**UNITED NUCLEAR
CORPORATION**

SUBJECT: SNM-777 LICENSE FOR FUELS RECOVERY PLANT,
WOOD RIVER JUNCTION, RHODE ISLAND

INSIDE STORAGE FACILITIES
STORAGE SHELVES (REF. PARAGRAPH 504.3)

INSIDE STORAGE SHELVES.
REF. PARAGRAPH 504.3

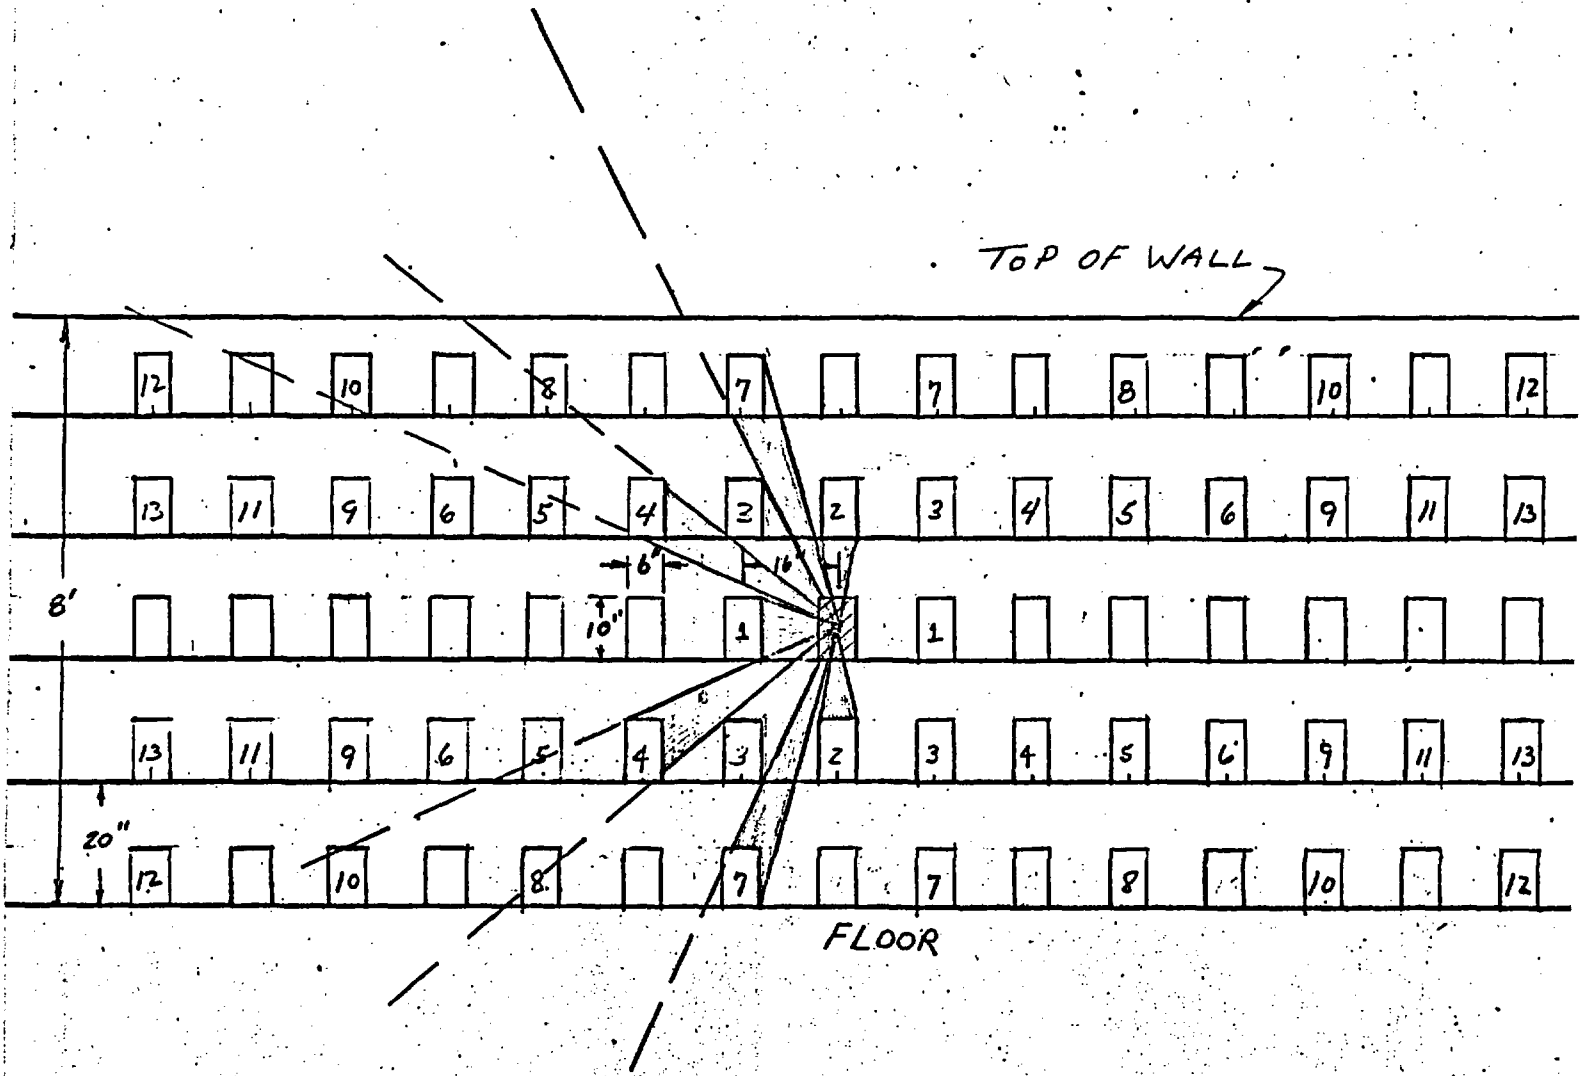
WE ARE RESPECTFULLY REQUESTING AMENDMENT OF SNM-777 TO INCLUDE A REVISION TO THE STORAGE ARRAY DESCRIBED IN PARAGRAPH 504.3 OF "GENERAL INFORMATION AND PROCEDURES APPLICABLE TO THE HANDLING OF SPECIAL NUCLEAR MATERIAL". THE ONLY CHANGE IN THE ARRAY IS THE HORIZONTAL SPACING OF INDIVIDUAL CONTAINERS---THE ORIGINAL SPACING OF 32" CENTER TO CENTER BEING REDUCED TO 16" CENTER TO CENTER.

A REVISED SKETCH OF THE ARRAY AND SOLID ANGLE CALCULATIONS ARE SUBMITTED HERewith FOR YOUR REVIEW AND APPROVAL. YOU WILL NOTE THAT THE SOLID ANGLE CALCULATED FOR THE ENTIRE ARRAY IS 2.56 STERADIANS. THIS INCLUDES THE SOLID ANGLE SUBTENDED AT THE CENTRAL UNIT BY ALL THE NUMBERED UNITS ON THE SKETCH. HOWEVER, ONLY UNITS NUMBERED 1, 2, 3, 4 AND 7 ARE "VISIBLE" TO THE CENTRAL UNIT. THE SOLID ANGLE IN THIS CASE IS ONLY 2.10 STERADIANS. AS DESCRIBED IN PARAGRAPH 504.3, THE SAFE SOLID ANGLE IS 3.0 STERADIANS.

GRAND TOTAL 2.556

TOTAL FOR BOTTLES 1, 2, 3, 4, 7 IS 2.104 STERADIANS.
